Minimum Operational Performance Standards for Air Traffic Control Radar Beacon System/Mode Select (ATCRBS/Mode S) Airborne Equipment

Change 1

ED-73C, Change 1
MM DD, 20xx
Modifies EUROCAE ED-73C

Prepared by: WG-49

FIGURE 3-12: FLIGHT STATUS AND VERTICAL STATUS PROTOCOL

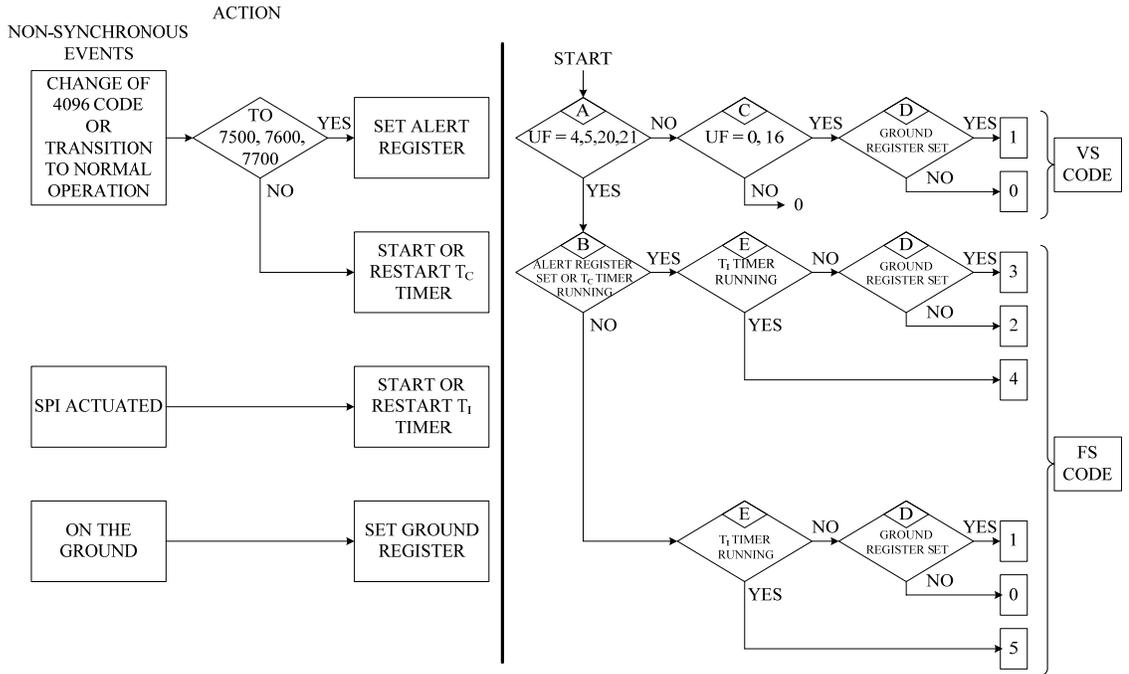
(1.45) In EUROCAE ED-73C, after section §3.31.4, as identified in Working Paper SC209-WP11-20R1, replace Figure 3-12 with the following:

FIGURE 3-18: DATA LINK TRANSPONDERS: B-PROTOCOL

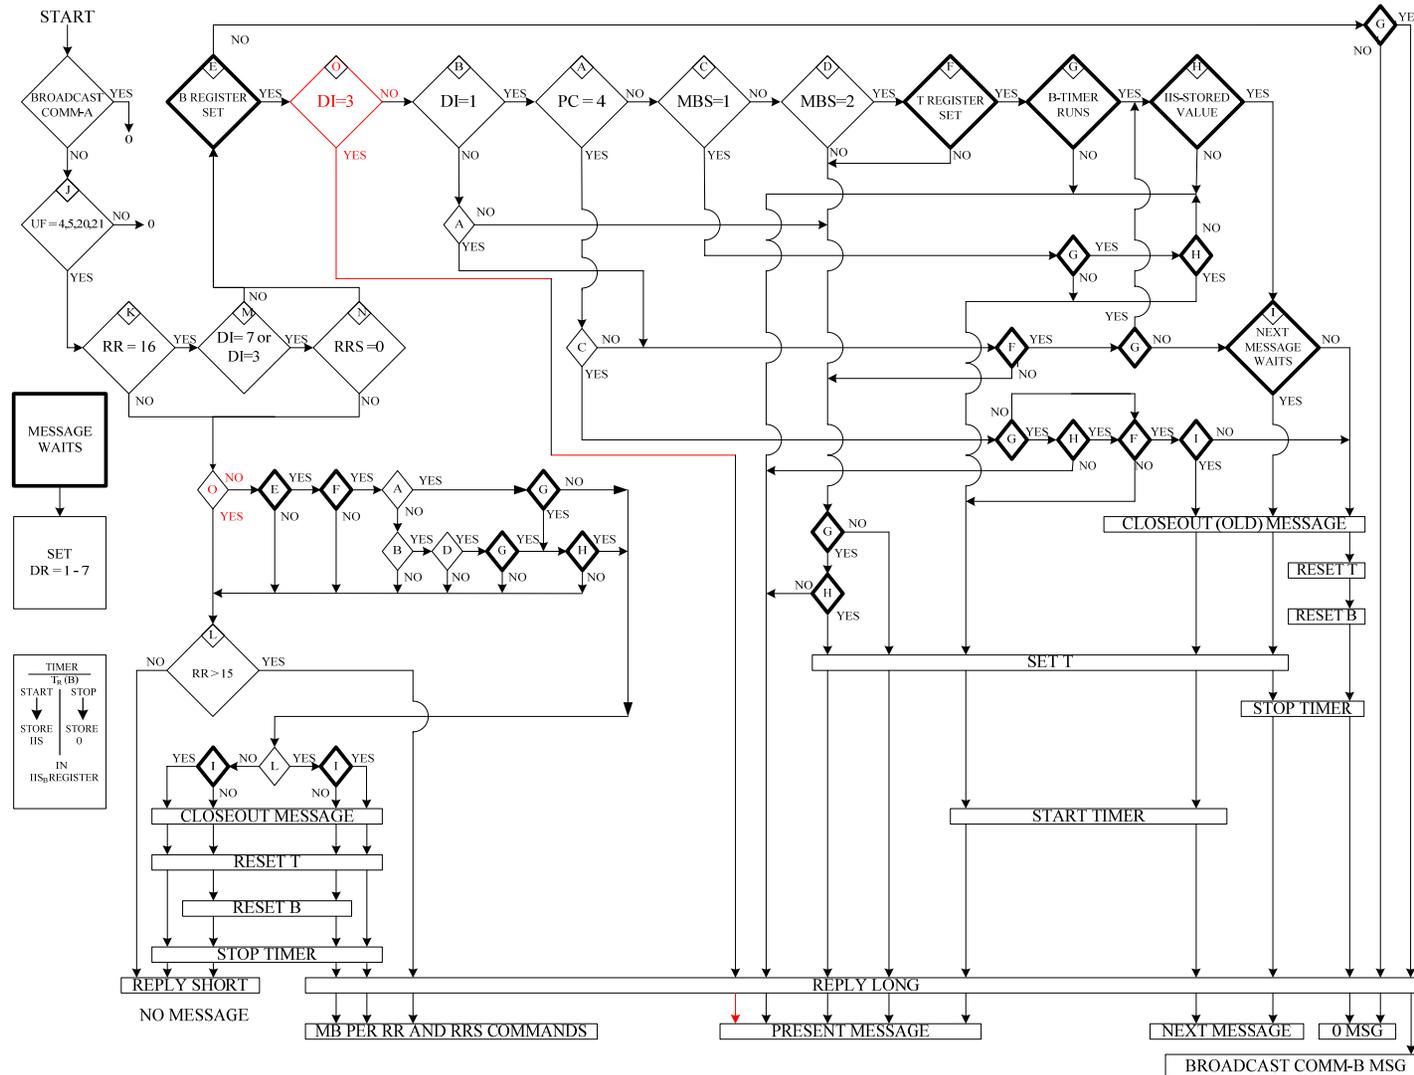
(1.46) In EUROCAE ED-73C, after section §3.31.4, as identified in Working Paper SC209-WP12-08, to account for DI=3, replace Figure 3-18 with the following:

FIGURE 3-18A: ENHANCED COMM-B PROTOCOL

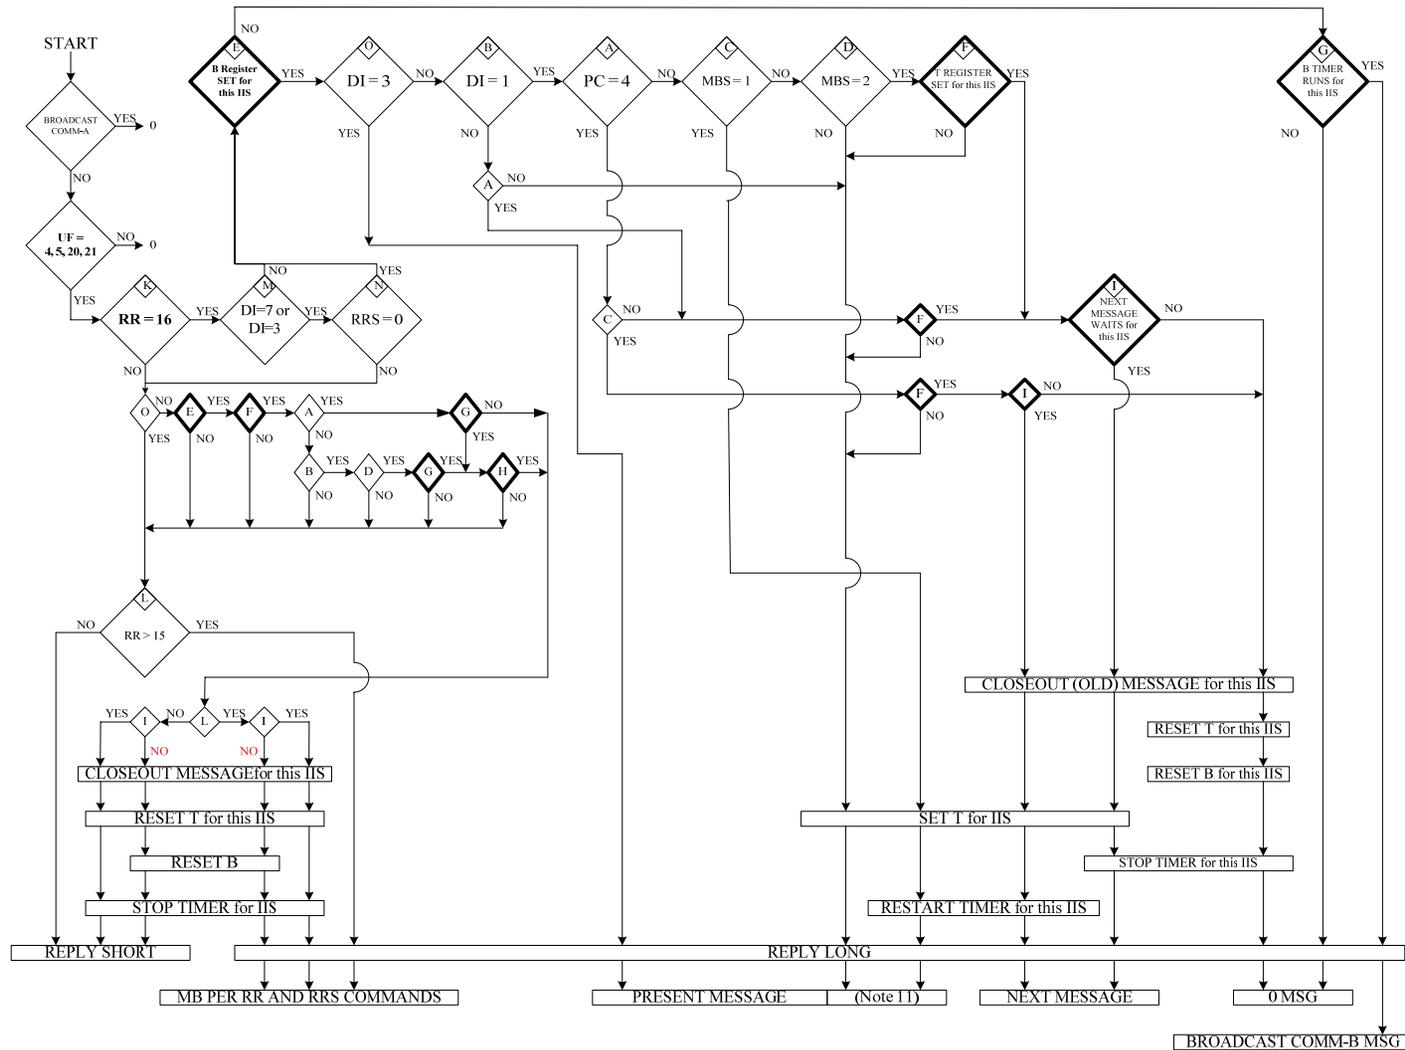
(1.47) In EUROCAE ED-73C, after section §3.31.4, as identified in Working Paper SC209-WP12-08, to account for DI=3, replace Figure 3-18A with the following:
